Bulletin

Application: Hyundai Motors: A4BF2
Subject: Valve Body Gaskets

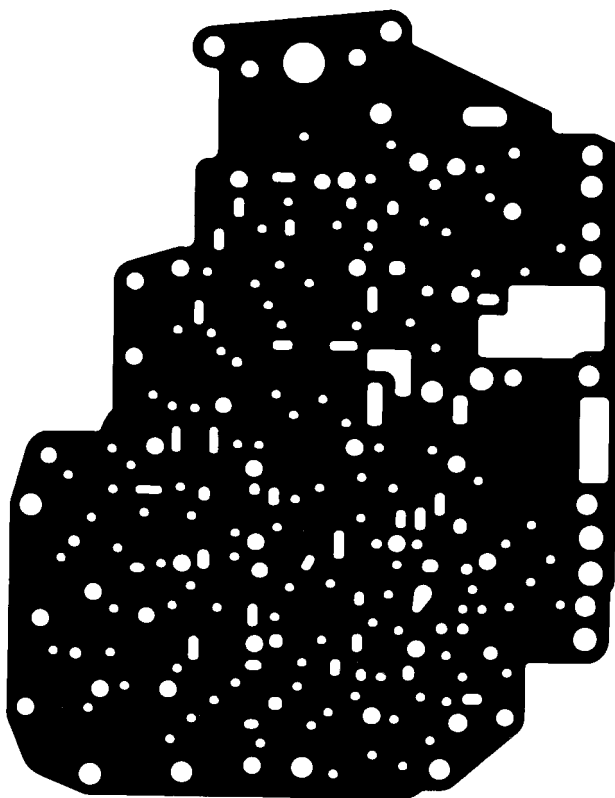
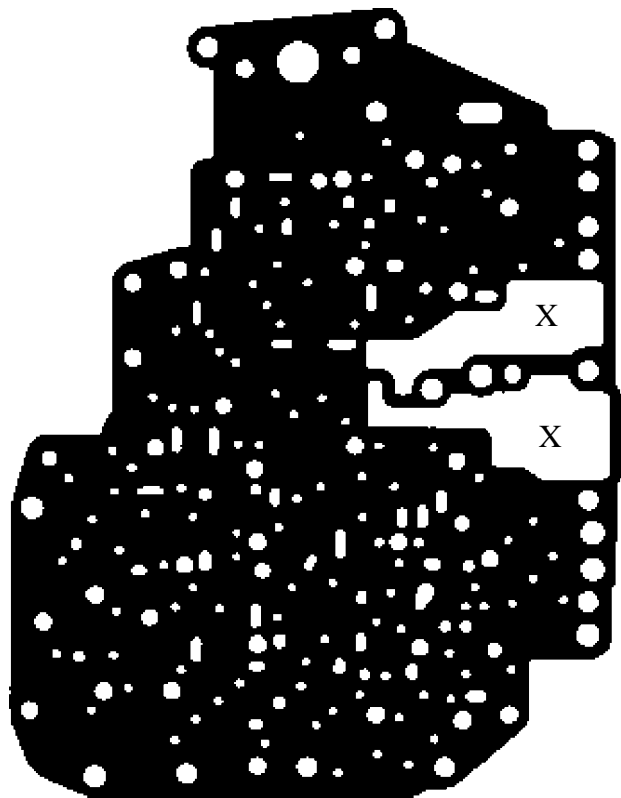
Hyundai Motors released an updated valve body gasket for all A4BF2 units built after 2/11/99. The new gasket has material removed from the suction and line pressure ports to reduce gasket blow-out concerns.

Prev. design, TransTec #12551 (OEM #46283-28000). Production dates 9/15/98 – 2/11/99.

New design, TransTec #12478 (OEM #46283-28001). Production dates 2/11/99 – UP.

All TransTec Hyundai kits are being updated with the new gasket as stock becomes available. The previous gasket can be modified to the current level until TransTec #12478 is available.
